TE Connectivity

Product Change Notification: P-26-031458

Receptacle Housing Change (C2)

C2 Housing Change PCN

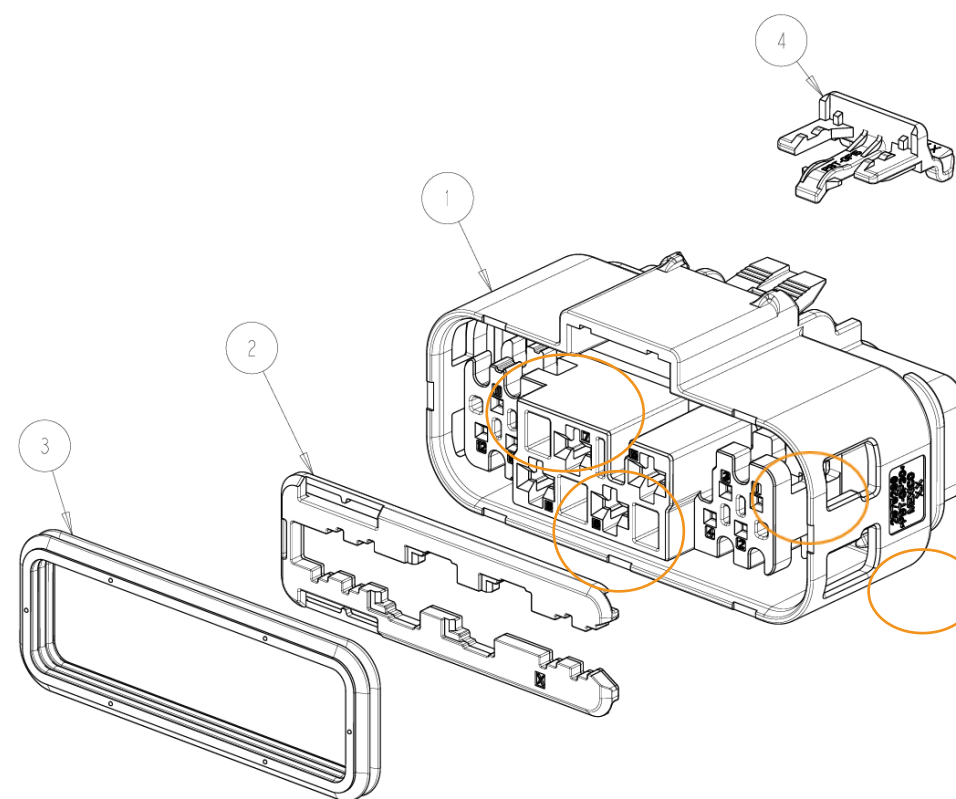
The receptacle housing design was revised to modify the geometry surrounding the terminal locking lance area. The updated design creates coplanar surfaces that improve terminal serviceability and reduce the potential for the locking lance to become trapped during terminal removal. The revised housing maintains compatibility with existing terminals and mating components. Connector finish good part numbers will be modified for this change. This change was reviewed and approved by Tableland. NOTE: During the introduction period, Housings could potentially be mixed with both current and revised ISL versions. The housing design is fully compatible with both versions of ISL. This was documented with Tesla through the deviation #TDEVVR-66975 & ISL change was communicated through the PCN#P-26-031169.

- Added internal support features to increase robustness around terminal retention areas.
- Revised housing cavity geometry to provide more continuous support surfaces and reduce localized stress concentrations.
- Added top-side feature for improved product identification and housing differentiation.
- Enhanced corner and end-wall geometry to improve housing strength and molding performance.
- No change to terminal interface or mating compatibility.
